REFERENCE
G.E. DWG 826222CA SH.17 REV.4

THE CLEVELAND ELECTRIC ILLUMINATING CO.
PERRY NUCLEAR POWER PLANT
ELECTRIC-ILLUMINATING DIVISION
CONTROL ROOM ANNUNCIATOR
ECCS BENCHMOUNTED UNIT

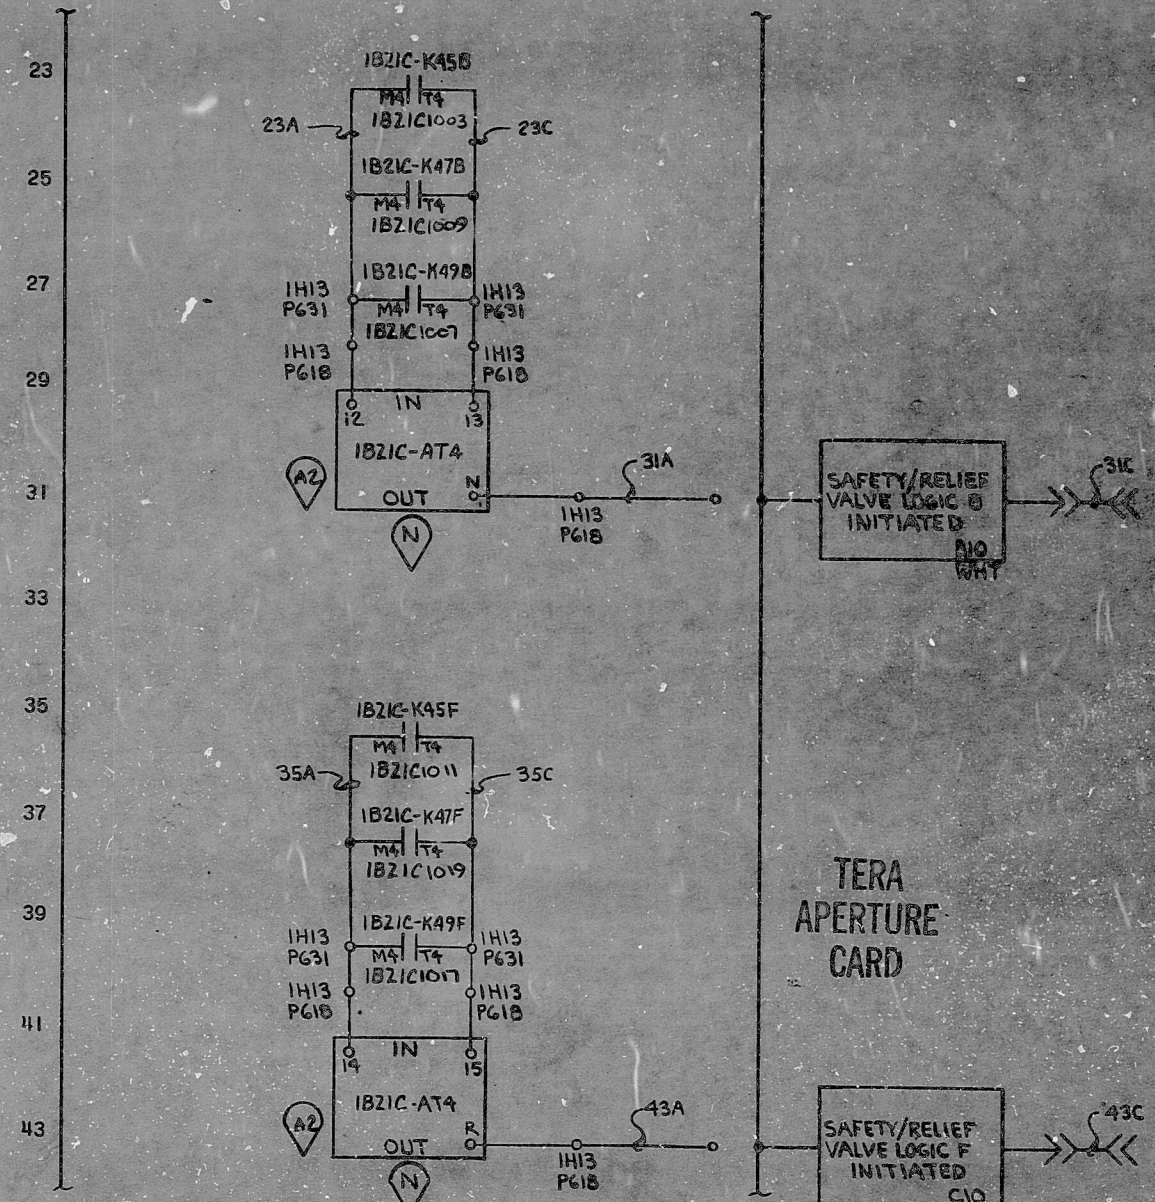
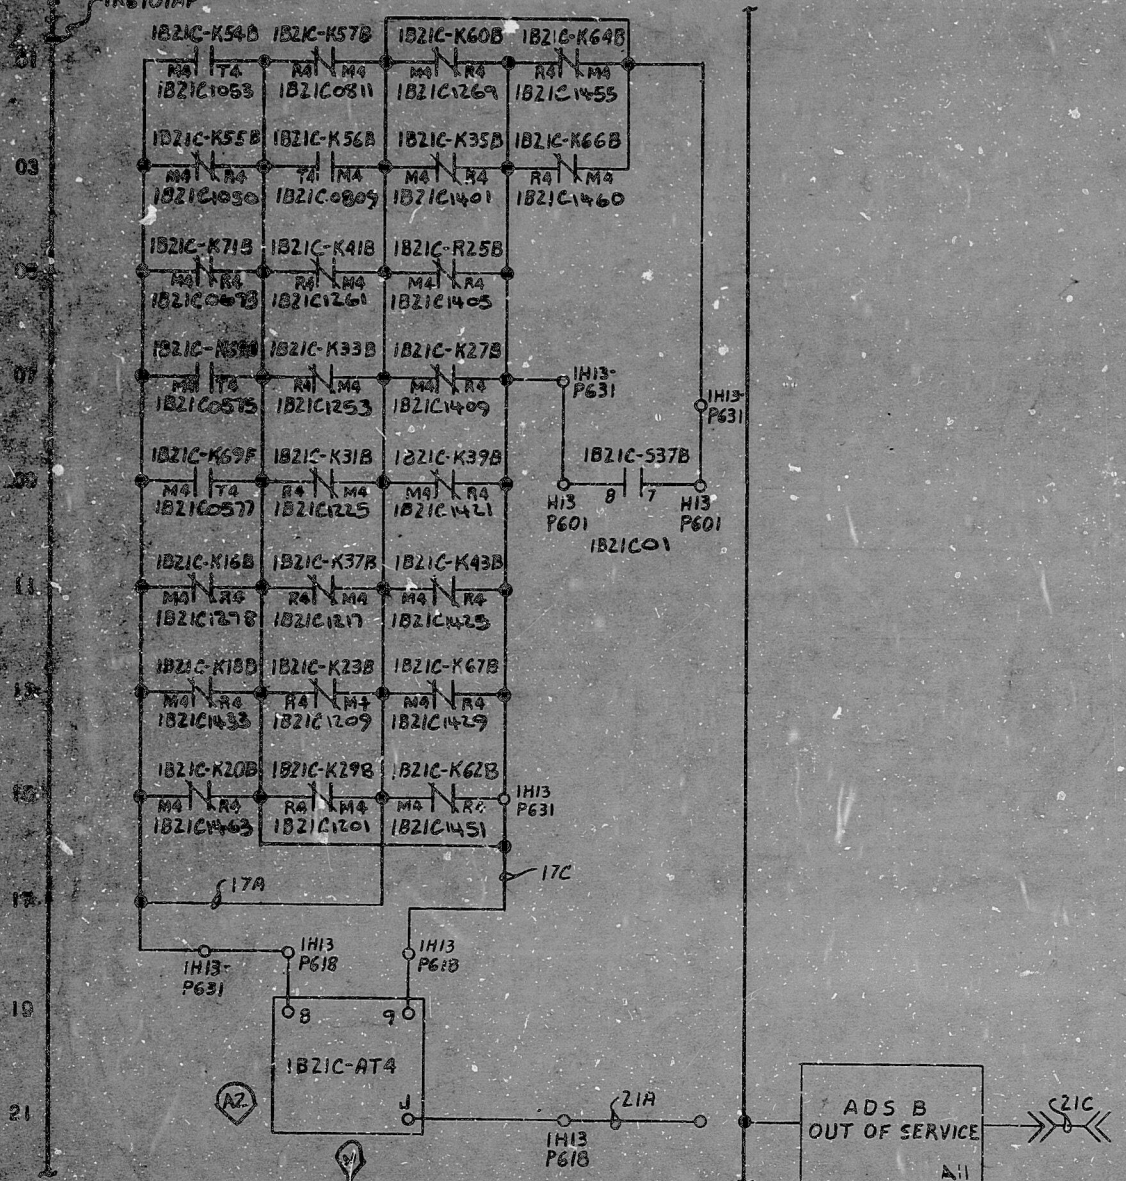
NO ECR REQUIRED.
ADDED ANNUNCIATOR
WINDOW NUMBER,
LINE 2.
CHANGED 1521C145F TO 1521C146F
ON LINE 2. CHANGED 1521C127F
TO 1521C128F ON LINE 11.
